LAND AT GREVATT'S LANE, CLIMPING STAGE 1 RSA – DESIGNER'S RESPONSE

LAND AT GREVATT'S LANE, CLIMPING

Stage 1 RSA – Designer's Response

**Land to the South of Grevatt's Lane, Climping.
Proposed Highway Works**

Client			SOUTHERN COOPERATIVE		
Project			GREVATT'S LANE CLIMPING		
Title			PROPOSED SITE ACCESS GENERAL ARRANGEMENT		
Drawn	BW	Checked	DM	Approved	(DF)
Original dtp. size	A3	Date of Issue	Dec 2018	Scale	1:1000
Drawing Status	PRELIMINARY		Drawing Number	BWREDE-SK01	Rev. P5

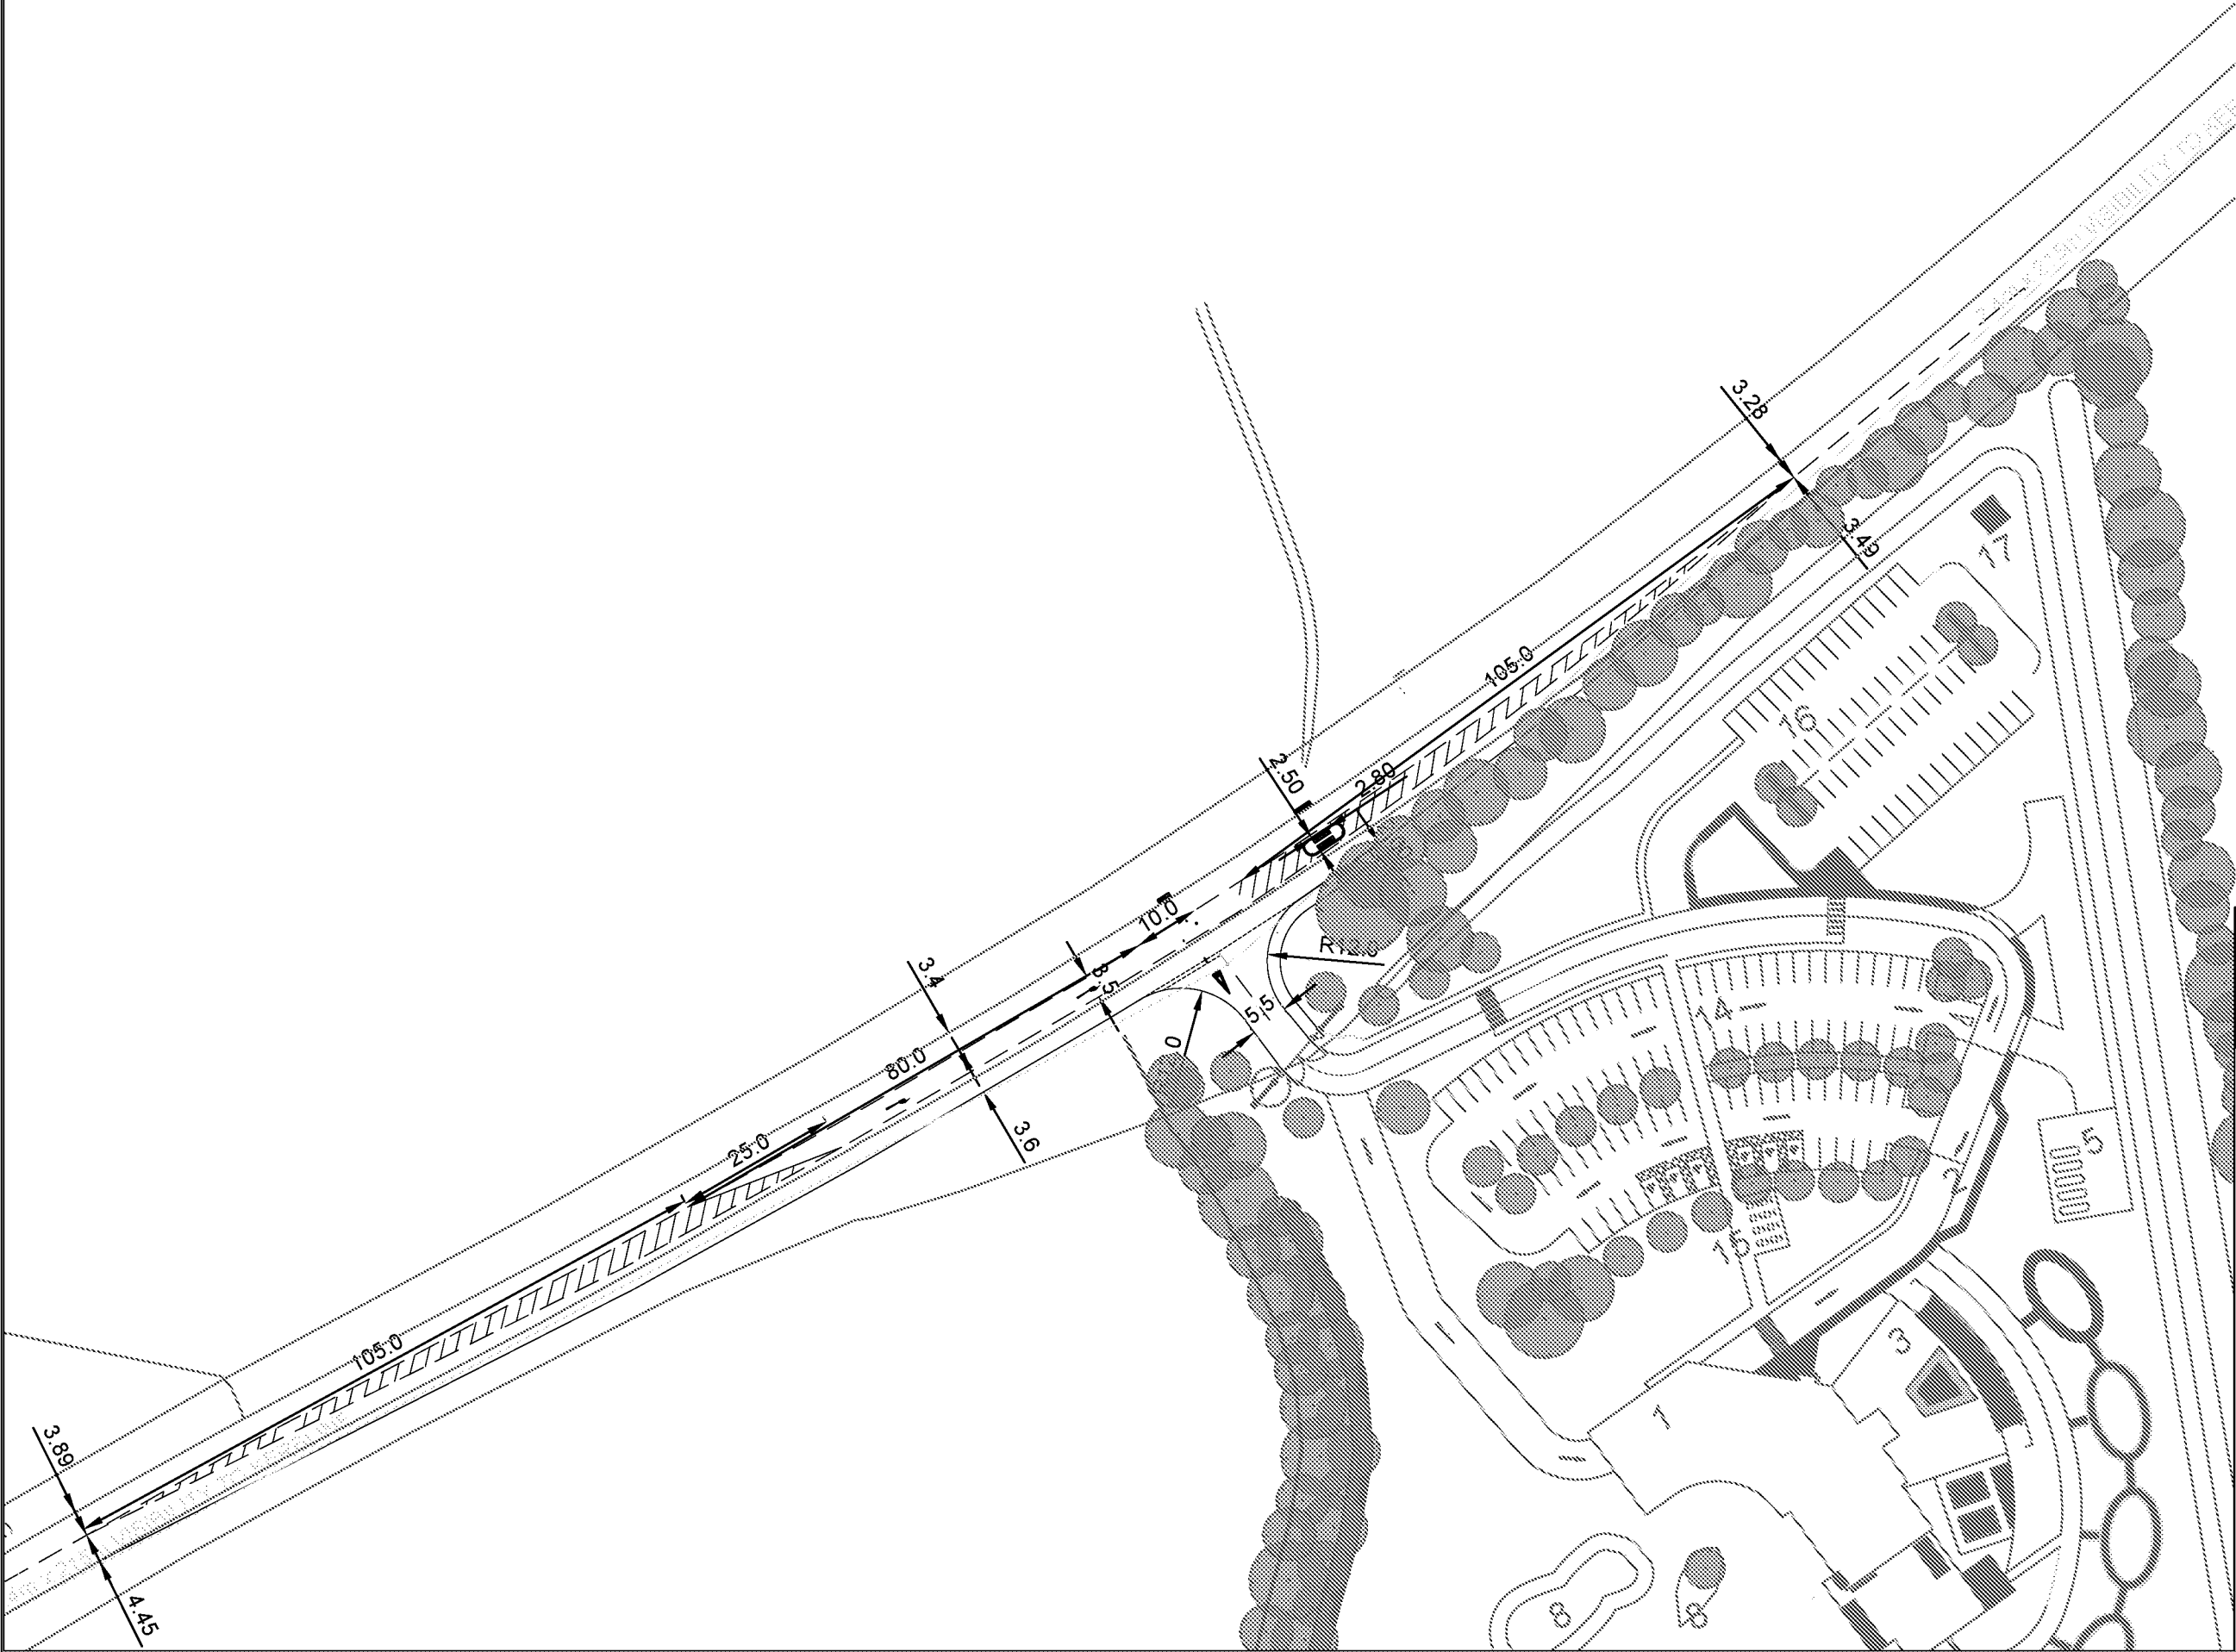
The widening of the carriageway in this location may encourage increased vehicle speeds. Services at the crematorium are likely to be tidal and may involve a greater proportion of elderly drivers. There is potential for risk of collisions between through traffic and turning vehicles.

It is recommended that the speed limit is reduced over this section of highway.

The pedestrian crossing facility may be used by dismounted cyclists seeking to cross from the shared facility on the northern side of the carriageway to the proposed development. There is a risk that cycles may project into the traffic stream where they are at risk of collisions with passing vehicles.

It is recommended that the refuge island is of sufficient width for dismounted cyclists to wait safely with their machines.

- 2.6.1 The existing Grevatt's Lane carriageway measures between 6.8m and 8.3m wide in the vicinity of the site, with existing lane widths of between 3.3m and 4.5m wide (narrowing from west to east). The through-lane widths have therefore been either retained as existing or narrowed over the length of the proposed site access and measure 3.4m and 3.6m wide. This is in accordance with DMRB TD42/95 guidance (Paragraph 7.20) which states that, 'at ghost island junctions, the through lane in each direction shall not be greater than 3.65m wide, exclusive of hardstrips, but shall not be less than 3.0m wide.' The proposed general arrangement drawing has been updated to show the existing lane widths at either end of the junction (drawing number BWREDE-SK01-P5) and is contained in **Appendix E**.

- 2.7.1 In accordance with WSCC's Section 278/38 Highway Agreement Standard Details (drawing no. S278/38/19 Rev D), the proposed refuge island has been revised to measure 2.5m in width and 2.8m in length. This is demonstrated in the updated general arrangement drawing (drawing number BWREDE-SK01-P4) as contained in **Appendix E**.
